SERVICE INFORMATION BULLETIN

Subject:
DESIGN CHANGE OF SUPPLY PUMP TO ACCOMMODATE NEW SUCTION CONTROL VALVE (SCV)

This document is to inform dealers and workshops of the design change to the supply pump and SCV for J08E-TV, TW engine series.

PREVIOUS	NEW
Part No.	22100E0101	22100E0102
Bushing	Less	With
Type of SCV	SV2	SV1
View of supply pump		
View of SCV

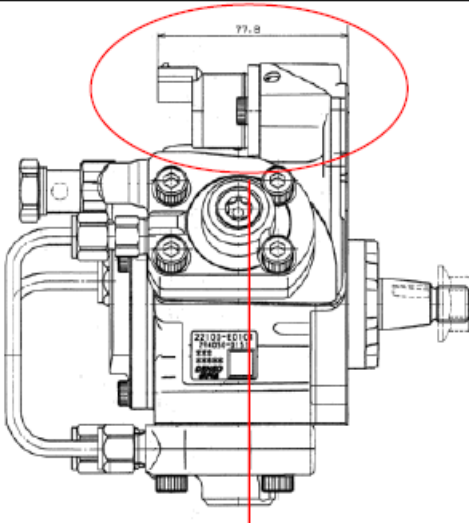
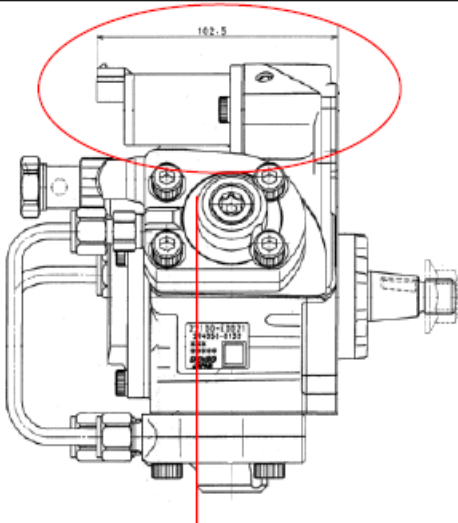
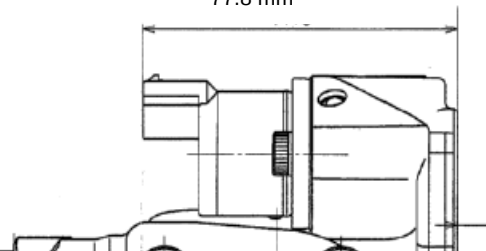
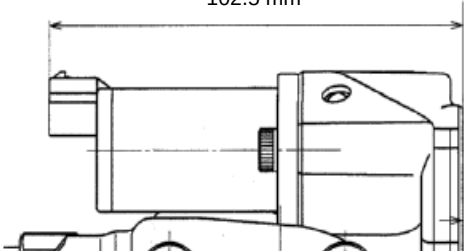
- A) The previous SCV has no bushing whereas the new SCV is designed with a bushing.
- B) The SCV part of the supply pump will be changed as described below.

The new part is interchangeable with the previous part as a pump assembly.
